621 CS-01 Before

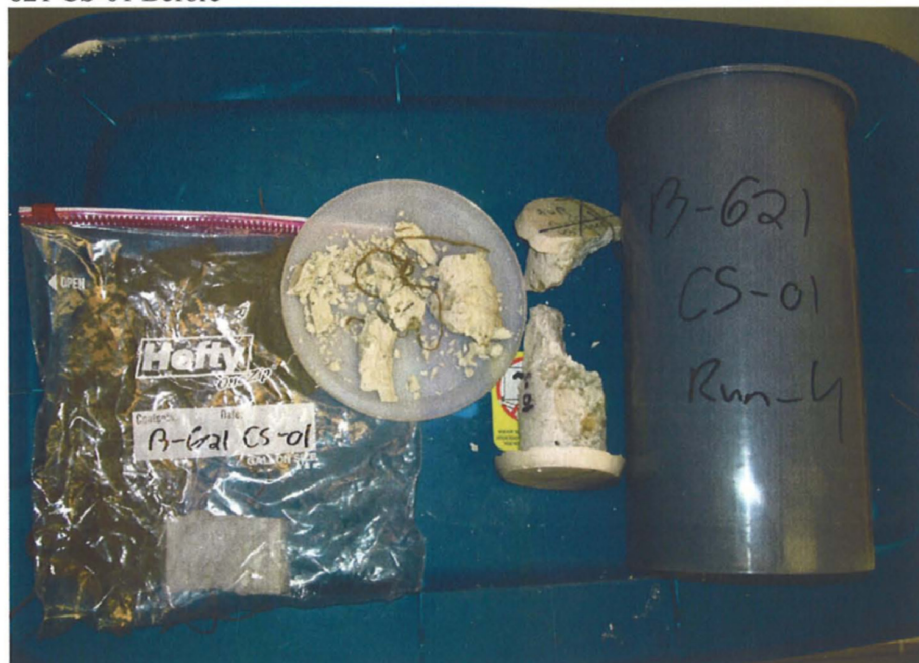
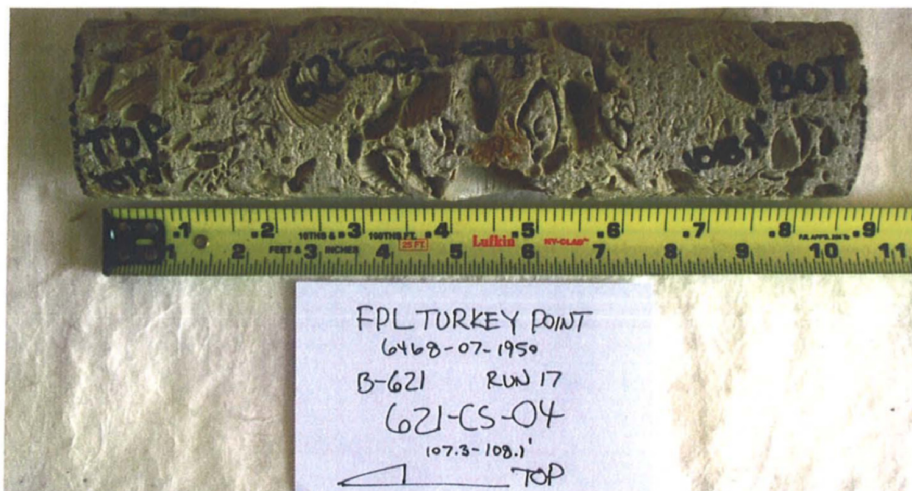
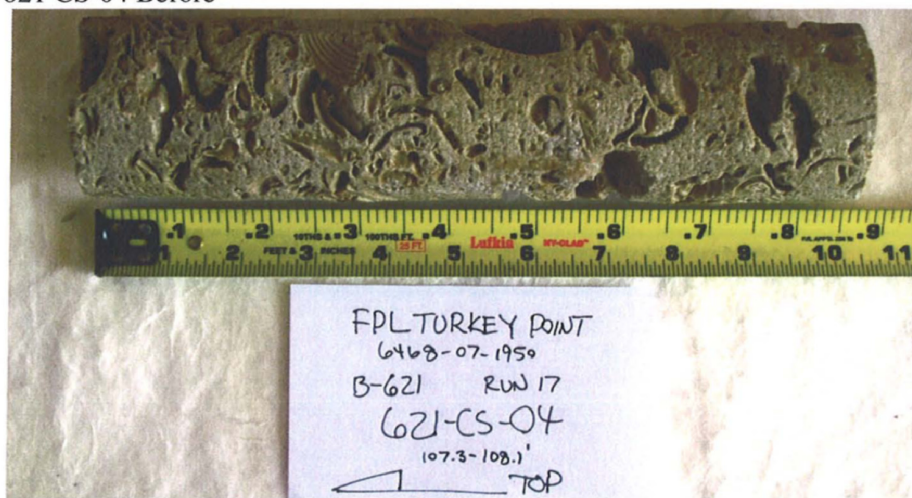
621 CS-01 Before

621 CS-01 After

621 CS-04 Before

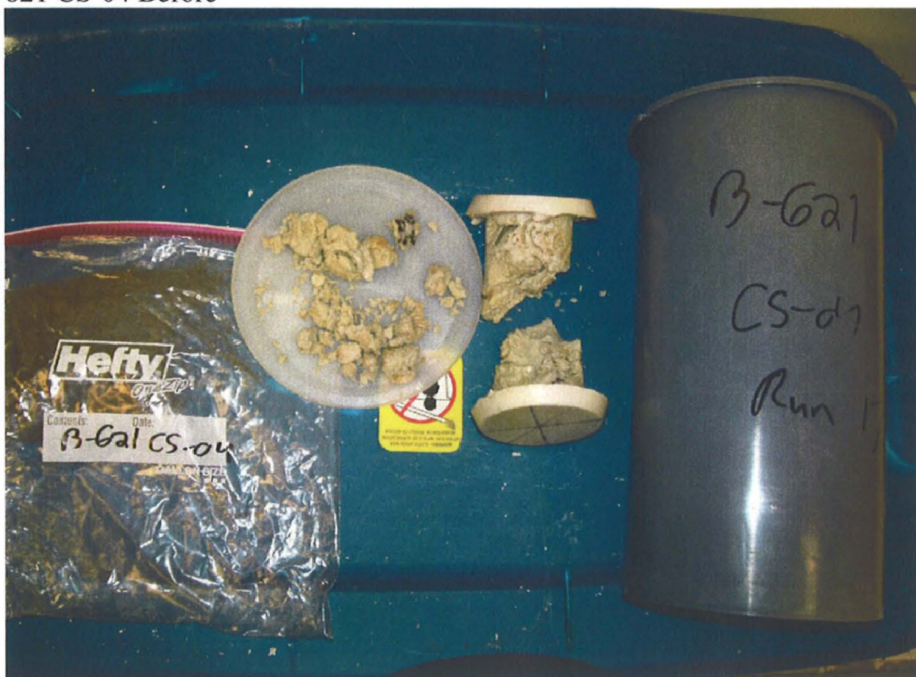
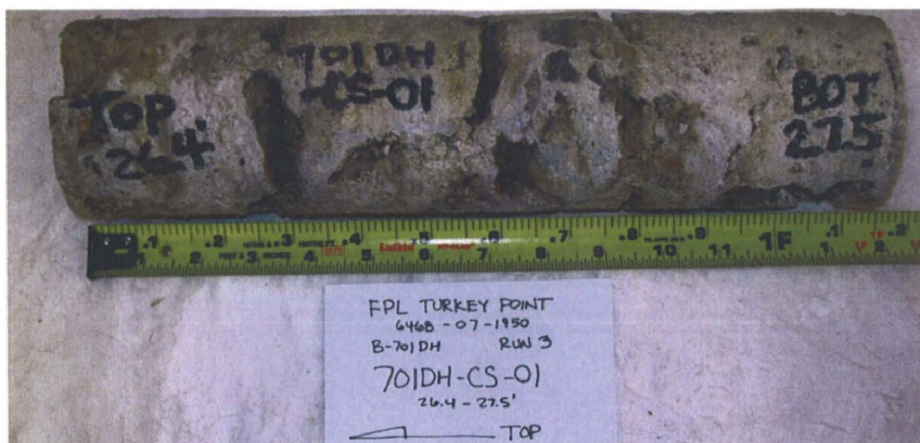
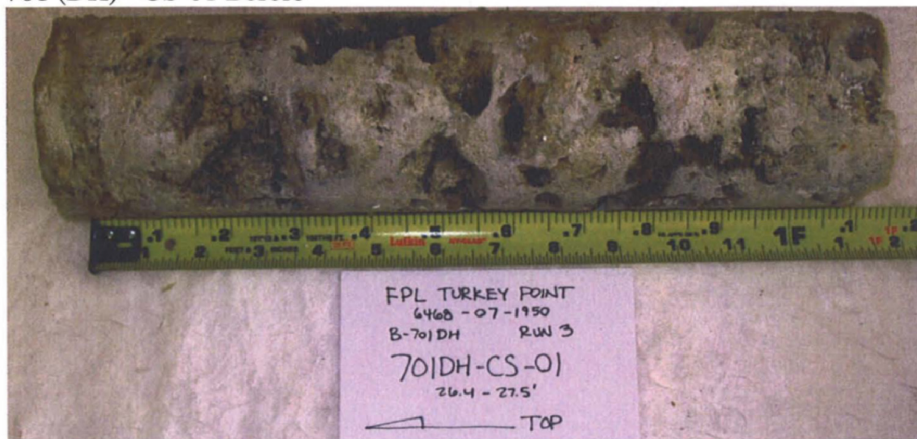
621 CS-04 Before

621 CS-04 After

701 (DH) - CS-01 Before

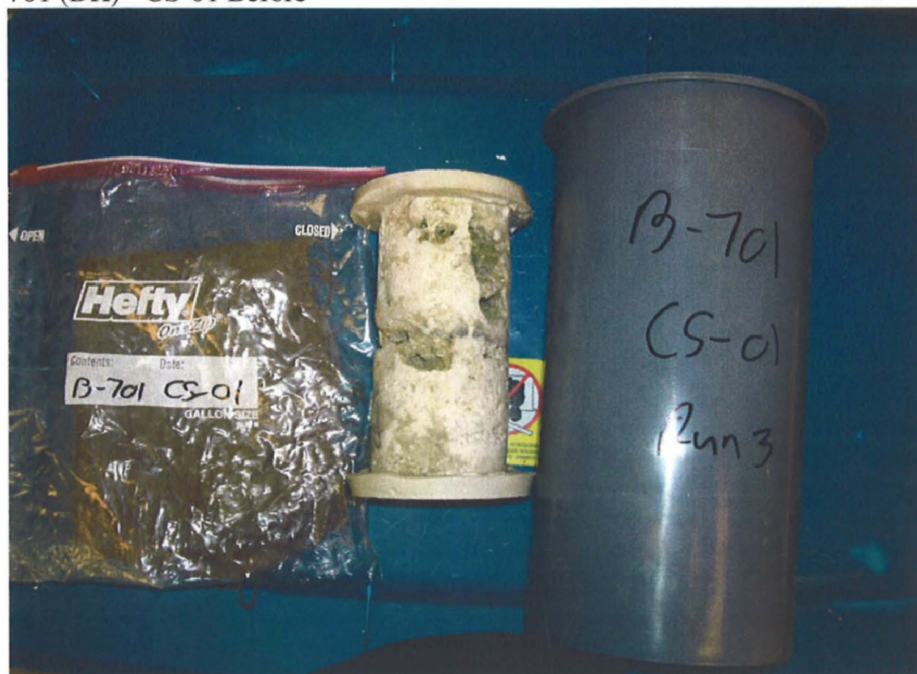
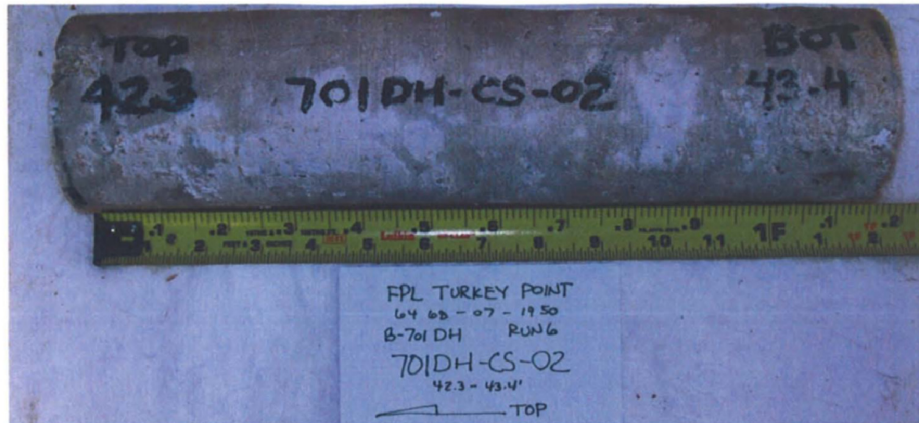
701 (DH) - CS-01 Before

701 (DH) - CS-01 After

701 (DH) - CS-02 Before

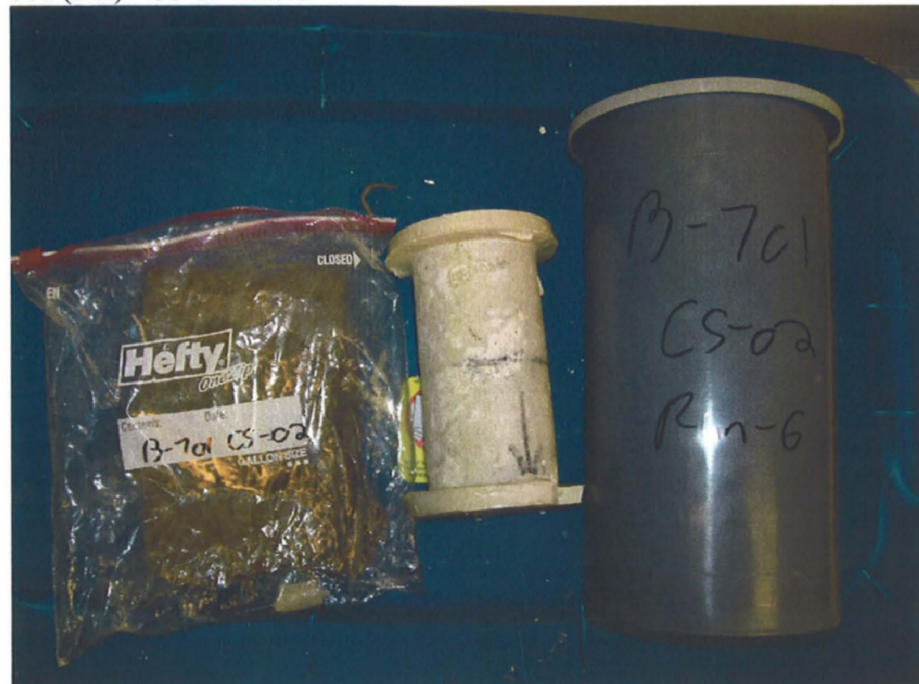
701 (DH) - CS-02 Before

701 (DH) - CS-02 After
